#### CITY OF KELOWNA

# MEMORANDUM

DP07-0222

TO AMEND PREVIOUSLY ISSUED DEVELOPMENT PERMITS

PROPOSED REVISED SITE PLAN

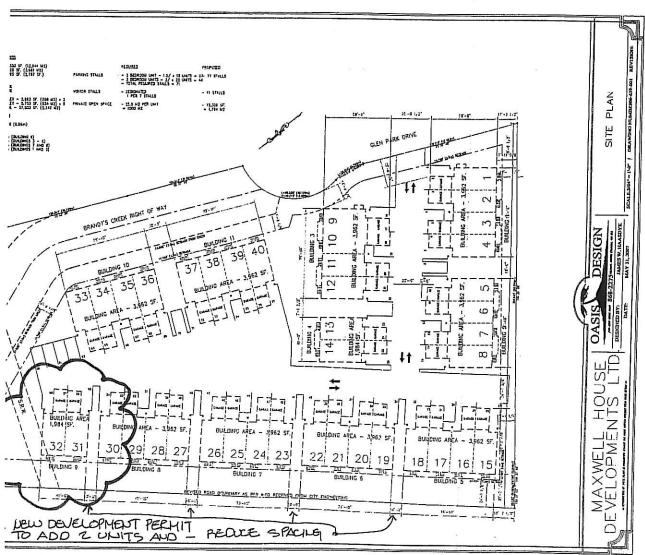
contemplated, the processing time can vary from 3 weeks to 3 months. The Land Department requires a full size copy, together with an 8 ? x 11 copy, of any survey plans. Land Comments for Processing Information Only - Not for Council Report: It appears that the new units are located over an existing sewer main ROW.

Provide spatial separation calculations related to proposed reduction in setback between buildings.

1.\_ This application to increase the number of units from 38-40 for the proposed townhouse development does compromise Works and Utilities servicing requirements as shown on the site plan submitted the additional units extend into Sanitary Sewer Right of Way.

- The dimensions and siting of the building to be constructed on the land be in 1. general accordance with Schedule "A";
- 2. The exterior design and finish of the building to be constructed on the land be in general accordance with Schedule "B";
- Landscaping to be provided on the land be in general accordance with Schedule 3.
- 4. The applicant be required to post with the City a Landscape Performance Security deposit in the form of a "Letter of Credit" in the amount of 125% of the estimated value of the landscaping, as determined by a professional landscaper;
- 5. The applicant register a Statutory Right of Way over relocated Sanitary Sewer

The applicant's consultant has provided a design for the relocated sewer line, and has demonstrated that it is possible to relocated
